Rampion 2 Wind Farm

Outline Construction Traffic Management Plan (tracked changes)

Revision F

Document Reference: 7.6

Figure 7.6.6c Local Access Routes

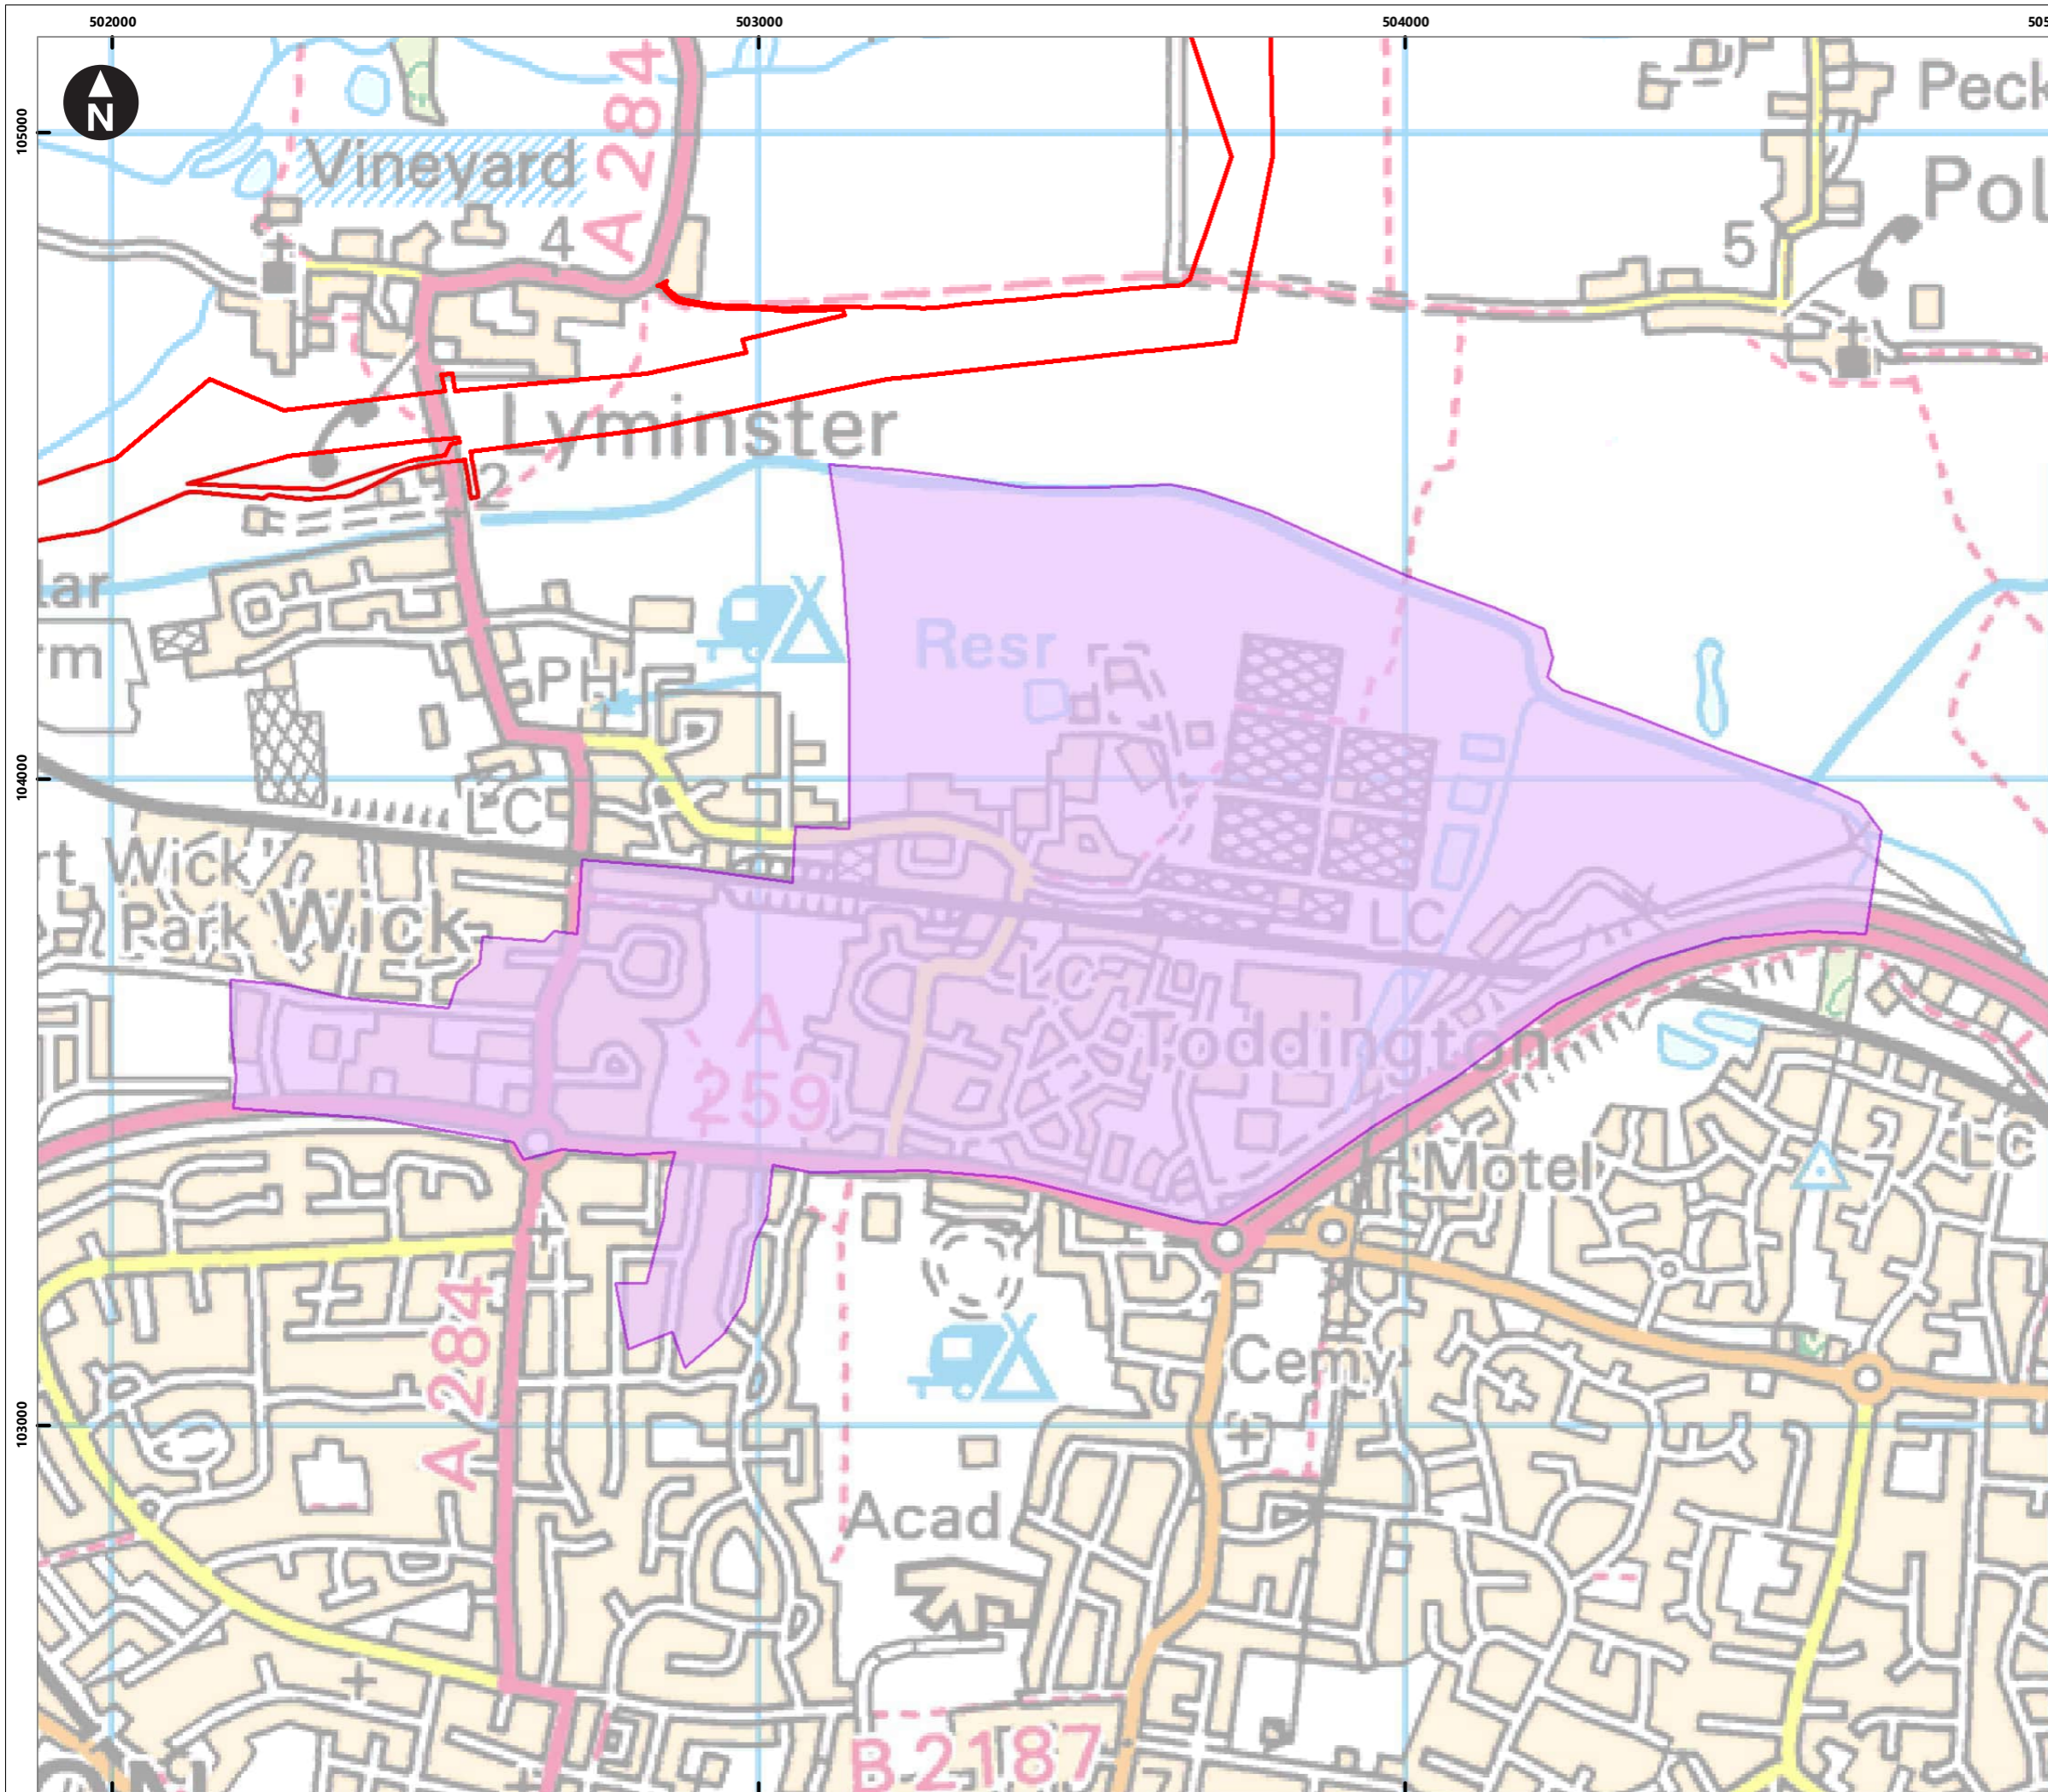
WSCC Local Impact Report Comment	Recommended Action	Applicant’s Response to WSCC Local Impact Report	Applicant’s amendment to the Outline CTMP
<p>Appendix B, Figure 7.6.6c The plan indicates HGV routing along the A272 through Cowfold from the west and using the A281 to the south. Some HGV activity through Cowfold is considered acceptable but in light of the Air Quality Management Area and existing traffic congestion, movements should be restricted. The majority of HGVs should arrive from the A23 to the east.</p>	<p>The plan should be updated to indicate HGV routing through Cowfold only where strictly necessary.</p>	<p>The Applicant will review this request and provide an update to the Outline Construction Traffic Management Plan [REP1-010] at Deadline 3 where appropriate</p>	<p>Additional text added to C-157 and C-158 to state that routing through Cowfold will only be for access A-56 and or A-57 or where use of locally sourced materials / equipment make its avoidance impracticable.</p> <p>In addition, vehicles restrictions are now proposed within Paragraphs 8.4.18 to 8.4.21. These will be implemented through the Delivery Management System and use of bookable delivery slots.</p>
